Access Compliance Report Public Rights-of-Way (Curb Ramps)

Intersection ID: N/AMain Street:STEELE_CREEK_RDCross Street: HUNTING_BIRDS_LNLocation:NWADA ID: F35233D08874Ramp Type:PerpDiagInitial Pass/Fail: FailOverall Compliance: NoSeverity Score:8.75

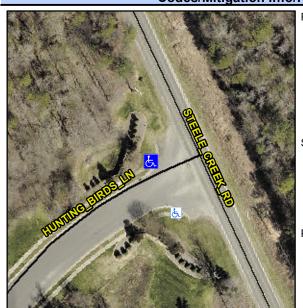
Not Found, R304.5.1

Remove & Replace Curb Ramp With Two New Directional Ramps or Equivalent.
